mercruiser STERNDRIVES & INBOARDS

service bulletin

No. 98-16

Bravo Drive Shaft Housing Replacement

a - Bravo One / Two Standard Insert Location
b - Bravo One / Two Optional Insert Location

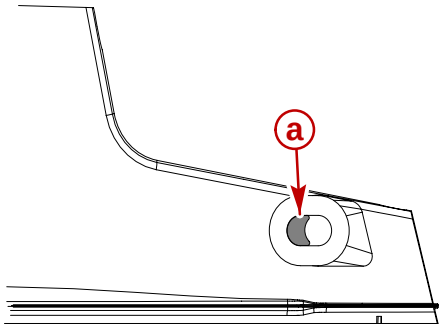
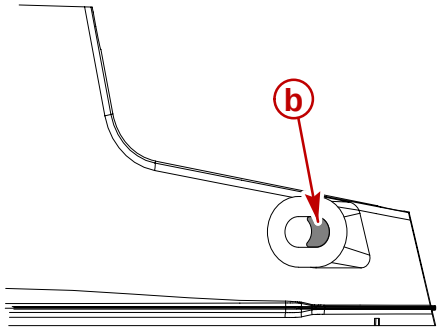
For the Bravo One and Two, the insert is placed in the **FORWARD most position** in the aft anchor pin hole. This placement will give the normal minus 5 degrees of trim under. The insert may be placed in the **AFT most position** of the slotted hole to limit the amount of trim under for boat hulls requiring less trim under.

The 1589-8868A25 and 1589-8868A55 drive shaft housings will supersede to the 1589-8868G21 drive shaft housing. The anchor pin hole changes from the round aft anchor pin hole to the elongated (slotted) aft anchor pin hole. The elongated (slotted) aft anchor pin hole requires the use of a crescent shaped insert (808006). This insert is included with the housing to position the pin placement for Bravo One / Two / Three.

a - Trim-In Limit Spacer Location

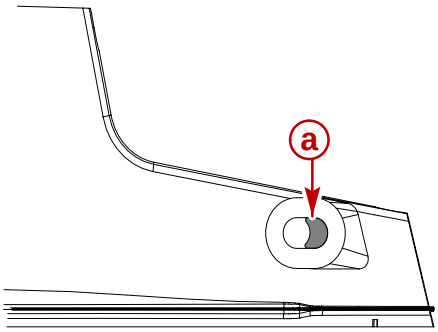
For the Bravo Three drive unit, the insert **MUST BE** placed in the **AFT most position** in the slotted hole to limit the Trim Under.

When the 1589-8868G21 housing is used on a Bravo Three drive unit, the Trim-In Limit Blocks (806692A2) will no longer be required. **DO NOT** reinstall them on the drive unit. If the blocks are already installed, they **MUST BE REMOVED**.

After placing the insert in the AFT most position of the slotted hole, install a Tilt Limit Spacer Kit (15768A3). Use 1 spacer per cylinder as shown below to prevent the bell housing and drive shaft housing from contacting the gimbal ring U-Bolt.
